## Application to amend works approval

<b>Works approval number</b>	W5995/2016/1
<b>Applicant</b>	Habrok (Battler Pit) Pty Ltd
<b>ACN</b>	632 755 438
<b>DWER File Number</b>	DER2016/000903-1
<b>Premises</b>	Battler Gold Project Southern Cross-Marvel Loch Road SOUTHERN CROSS WA 6426  Part of Mining Tenement M77/1285 As defined by the coordinates in Schedule 1 of the works approval
<b>Date of Report</b>	3 February 2020
<b>Status of Report</b>	Final

**Figure 2: Evaporation pond relative to topography**

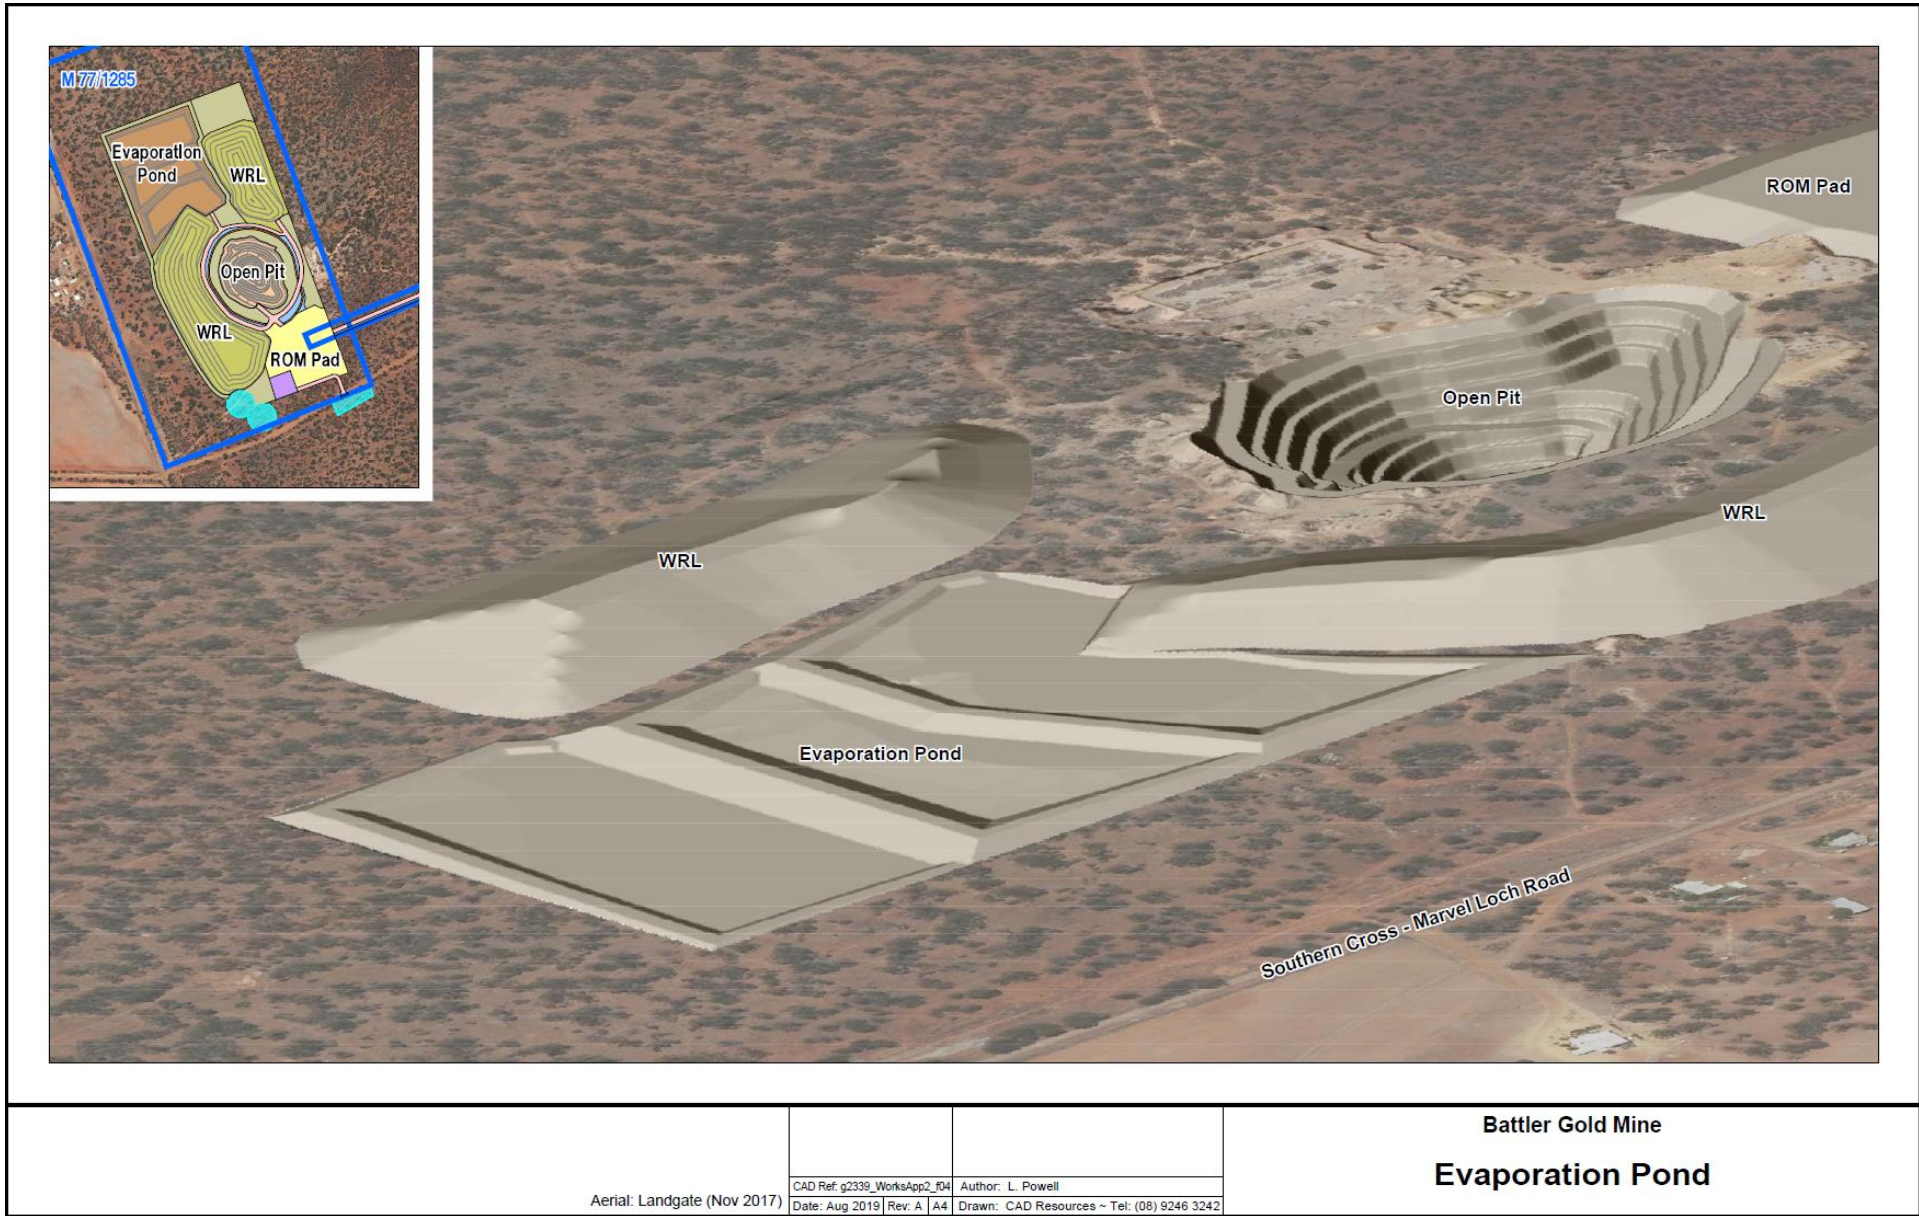
On 19 September 2019, the applicant submitted an amendment to the existing works approval W5995/2016/1 for Category 6 – Mine dewatering only. The approved evaporation pond design, as described in the existing works approval, required a significant amount of material to be cut out of the existing landscape due to the topography of the area. A revised design has been developed to reduce the amount of material required to be cut out, while still minimising the risk of lateral seepage. Figure 2 displays the new design as it relates to the topography of the area.
